MAINTENANCE BULLETIN

NO. 163
SEPT 1999

ALFA COMPANY

E89128

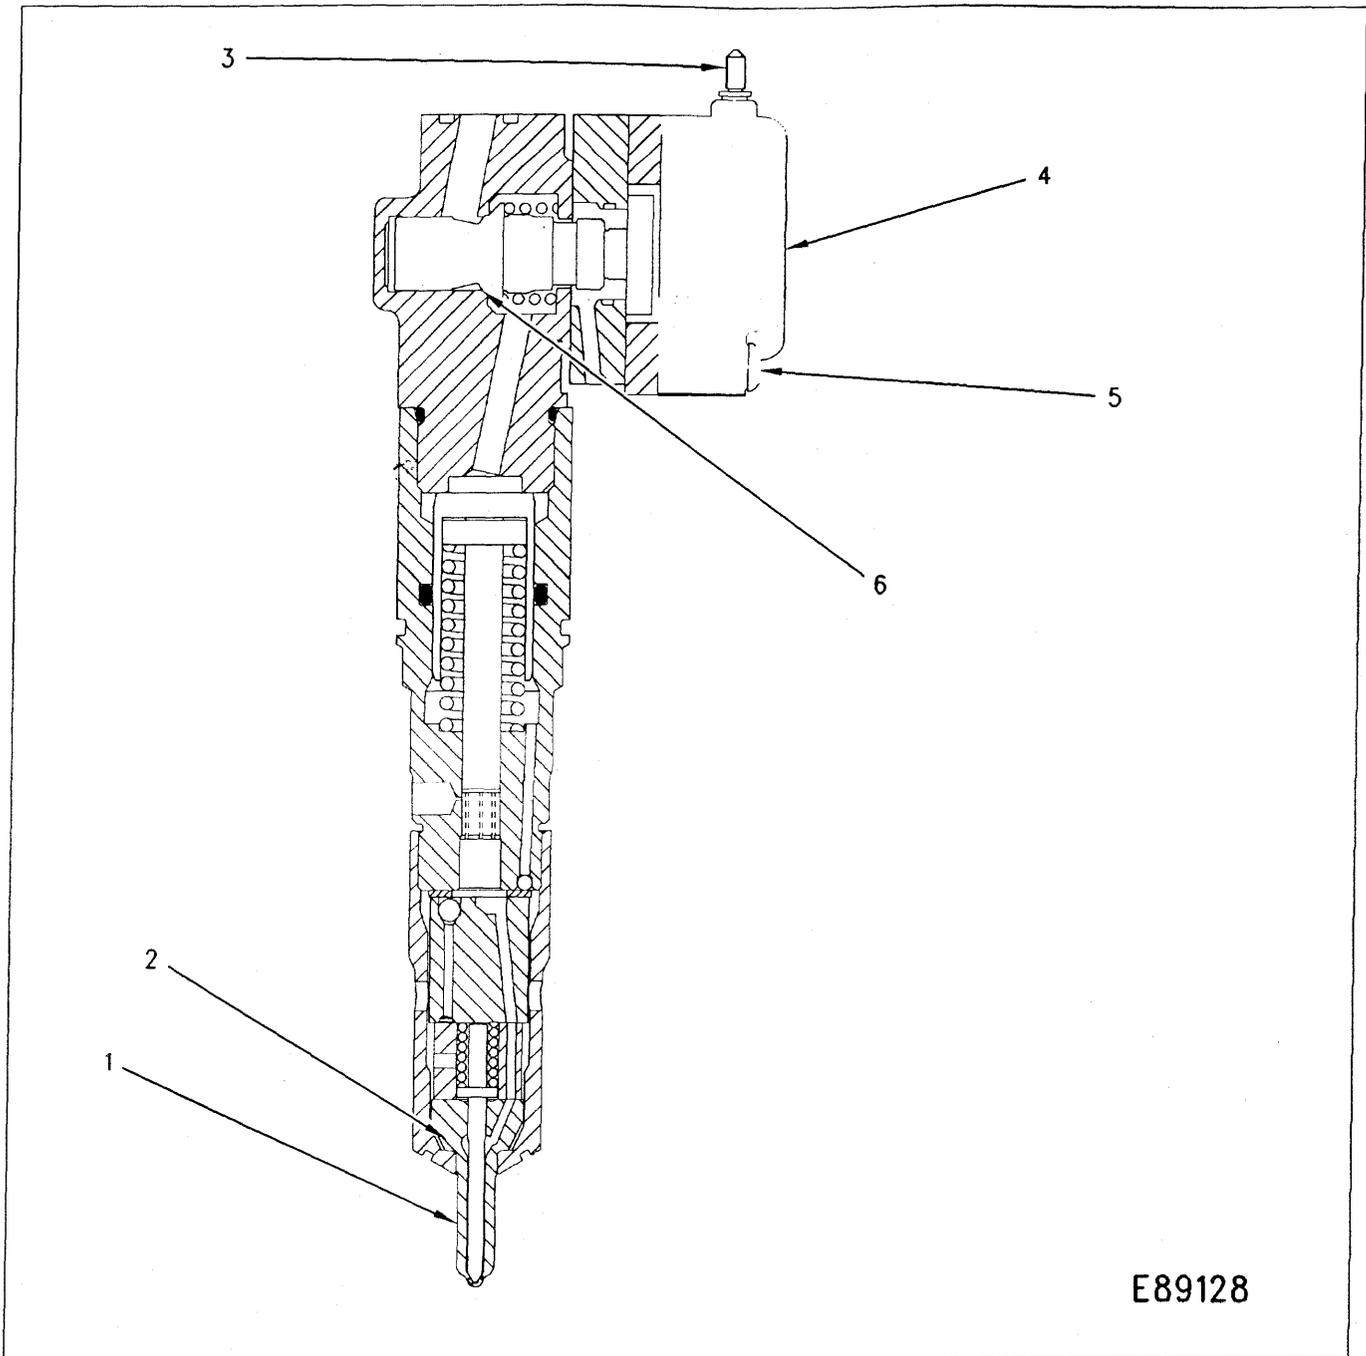
Description Of Change: Several improvements have been made to increase the reliability of the unit injectors used in the 3408E and 3412E Engines. The new 174-7526 Injector has improvements to address the following problems:

- 1.) Nozzle tip splitting due to tip fatigue.
- 2.) Nozzle tip breakage due to side load from improper installation.
- 3.) Solenoid post loosening due to vibration.
- 4.) Solenoid failure due to internal shorting.
- 5.) Armature screw loosening due to manual torque control.
- 6.) Low power complaints due to cavitation erosion of the injector lower poppet seat.

1.) Nozzle tip splitting due to fatigue was observed on some early engines. This failure typically resulted in the tip splitting through an orifice hole and piece of the tip near the end breaking out. This problem was eliminated through several design and process changes which increased the tip wall strength and reduced the check impact at the end of injection. Tip strength has been increased by using a thicker tip wall. Check impact load has been reduced by a design change to increase the check damping and to reduce the check lift.

2.) Nozzle tip breakage where the entire shank portion of the tip breaks off near the end of the nozzle case has been seen on some field-replaced injectors. This is a result of side-loading on the tip at injector installation, which occurs when carbon deposits in the tip hole of the injector sleeve are not properly removed. This problem has been addressed by implementing a new plug gauge which is used prior to installing the injector, and ensures that adequate clearance is available at the point of use. In addition, a new cleaning brush was released to facilitate cleaning the hole, instructions were improved, and a special warning wrapper (with international symbols) was affixed to each service injector to alert the installer to the proper procedures. New packaging was also implemented to better protect service injectors during shipping and handling.

3.) Solenoid post loosening can occur due to fatigue from prolonged engine vibration. The original containment action to reduce the effect of the vibration was to add a rubber grommet to reduce terminal post movement. The permanent corrective action was to add additional epoxy material to the post. This provides a significant increase in strength and eliminates the need for the rubber grommet.

4.) Solenoid failure due to internal shorting was caused by frayed wire insulation from prolonged exposure to engine vibration. This problem was addressed by using wire with a bondable insulation. This new insulation is heat bonded with insulation from adjacent wires forming a single mass that is much stronger and vibration resistant.

5.) Armature screw loosening occurred to some injectors due to a manual torquing process used during assembly. This manual process has been eliminated and replaced by a computer controlled automated torquing process. The new automated process assures the correct clamping load on the armature to prevent armature screw loosening.

6.) Low power complaints due to cavitation leakage of the injector lower poppet seat has been addressed through new software to reduce actuation pressure during high speed, low fuel delivery conditions. Excessive actuation pressure at low fuel rate conditions cause a vacuum bubble to form at the lower poppet seat when the poppet closes. Continued exposure to the implosion of the vacuum bubbles eventually causes cavitation damage to the lower poppet seat. This damage allows excessive leakage of actuation pressure, low fuel delivery and a low power complaint.

Adaptable To: The new 174-7526 Injector is a direct replacement for the former 159-0835, 138-8754, and 131-3098 Injectors on the engines in the above machines. The former injectors have been canceled.

New 139-5270 Steering Control Valve.
(1) 4T-4207 Orifice Plug

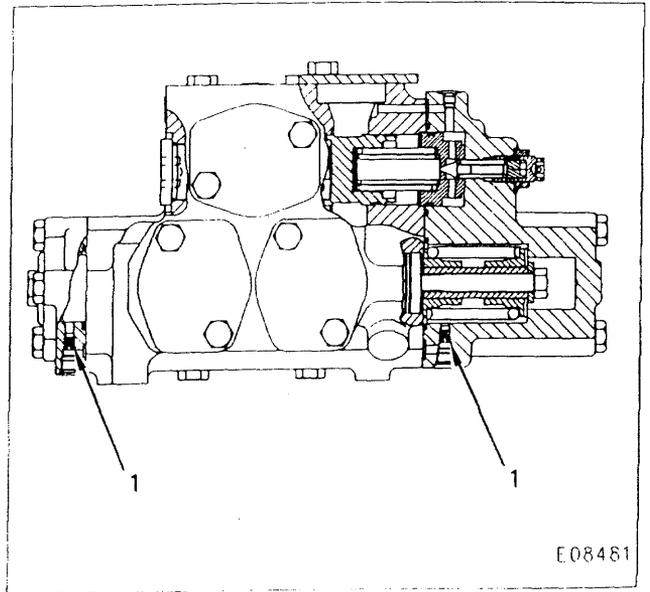
Description Of Change: A new steering control valve has replaced the former steering control valve in the STIC steering system. The check valve in the steering pilot system has also been changed.

The new steering control valve and new check valve reduces machine jerk when steering is initiated, making steering smoother and more controllable.

Adaptable To: Effective with 988F (2ZR563), the new 139-5270 Steering Control Valve replaced the former 128-5347 Steering Control Valve, and is adaptable to earlier machines. Also, a new 111-7775 Check Valve replaced the former 6E-3723 Check Valve.

Effective with 988F (2ZR988), a new 149-4617 Check Valve replaced the 111-7775 Check Valve and is adaptable to earlier machines.

The former 128-5347 Steering Control Valve can be upgraded to the new 139-5270 Steering Control Valve by replacing the 4J-9780 Orifice Plug in the end covers with 4T-4207 Orifice Plug (1).

Note: If the 128-5347 Steering Control Valve is upgraded, the former 6E-3723 Check Valve must be replaced with the new 149-4617 Check Valve.

View A. Typical of Cylinders Using Later 9T-7350 Head With Snap Ring Groove.

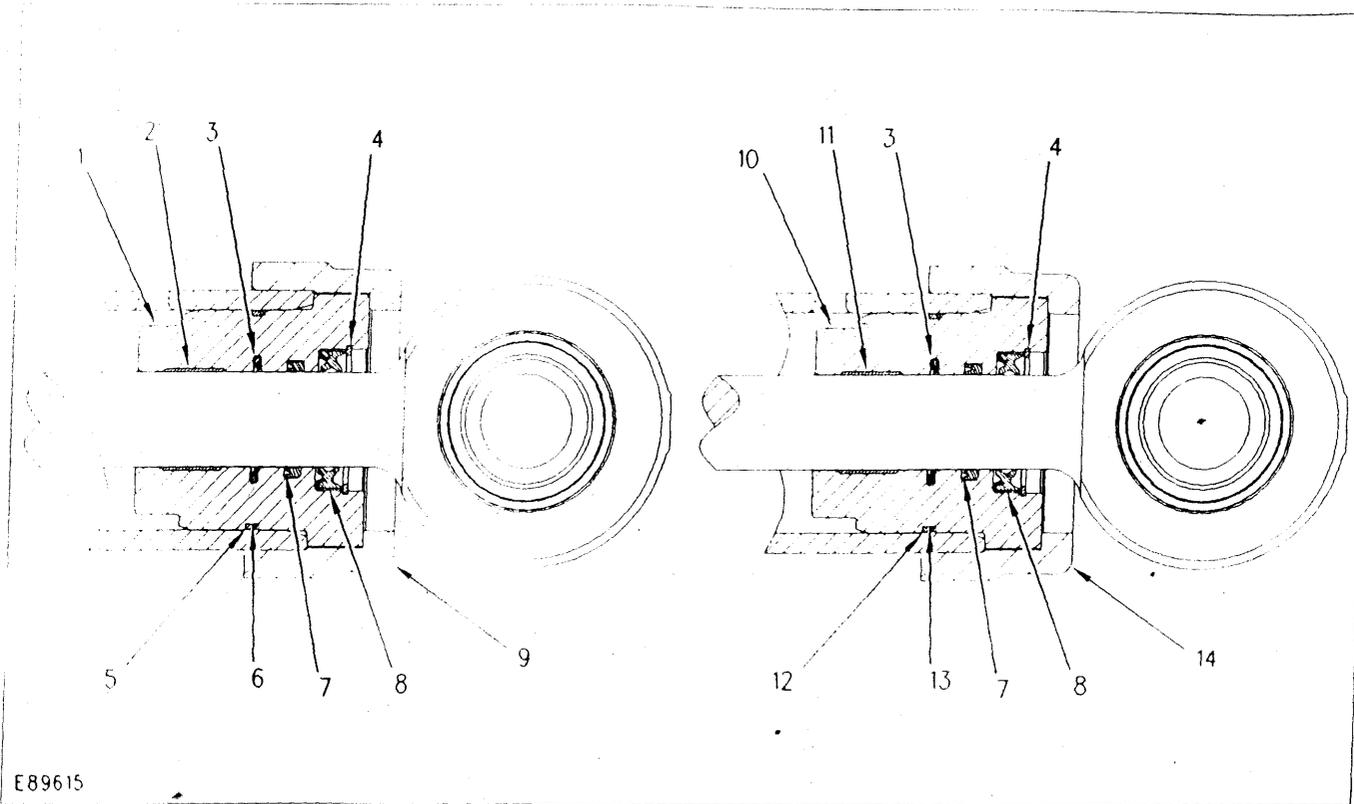
Description Of Change: A snap ring now retains the rod wiper seal in steering, angle, lift, tilt, and scarifier cylinders listed in this article. The snap ring prevents the rod from pulling the wiper seal out, especially during cold weather.

Adaptable To: 006-8663 Ring (4) was effective with the engineering change number for cylinders listed in Chart A.

006-8663 Ring (1) is adaptable to earlier cylinders, without snap ring groove, as follows:

- Replace earlier 9T-7350 Head with later 9T-7350 Head (1) with snap ring groove.
- Install 006-8663 Ring (4).

- Replace former 8J-0556 Head with later 9T-7350 Head (1) with snap ring groove.
- Install 8T-5443 Wear Ring (2).
- Install 006-8663 Ring (4).

Typical Tilt Cylinder

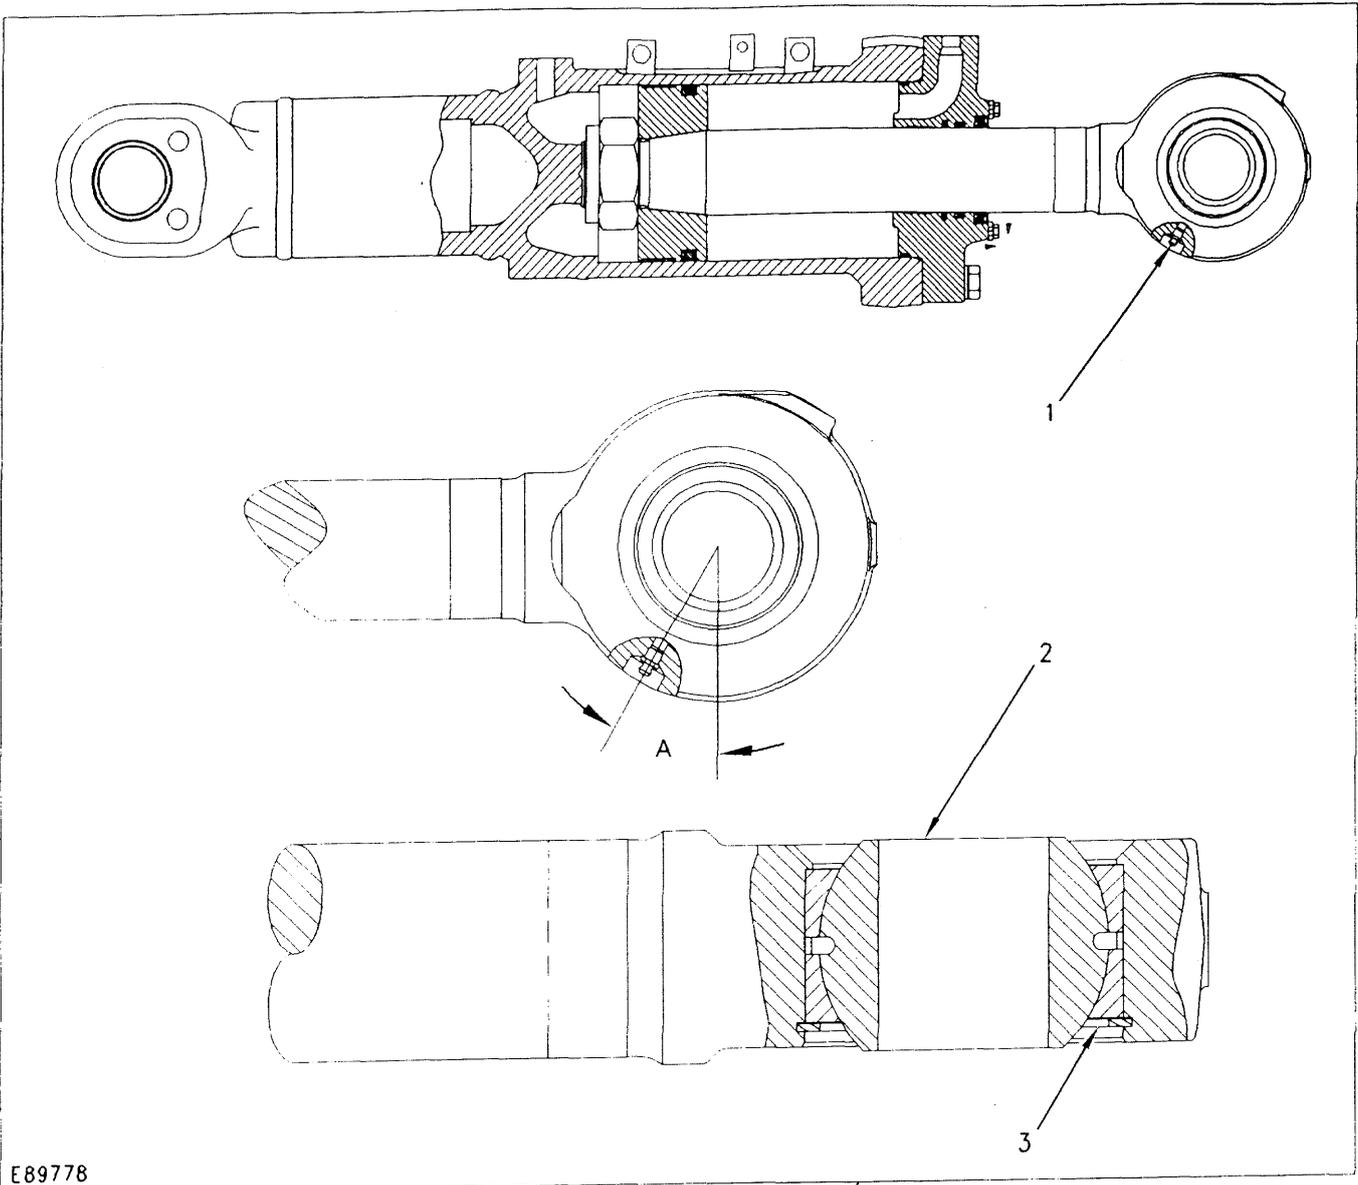
Description Of Change: A new bearing (self aligning) and a grease fitting, in the rod end of several tilt cylinders eliminate corrosion and seizure, associated with the former bearing.

Tilt cylinders with change number below the listed change numbers, can be upgraded in one of two ways:

1. Install rod having new 7J-3297 Bearing (2) and 3B-8489 Grease Fitting (1)
2. Rework existing rod by replacing former 6V-5340 Bearing with new 7J-3297 Bearing (2) and installing 3B-8489 Grease Fitting (1). See illustration for location of lubrication hole, and drill and tap specifications.
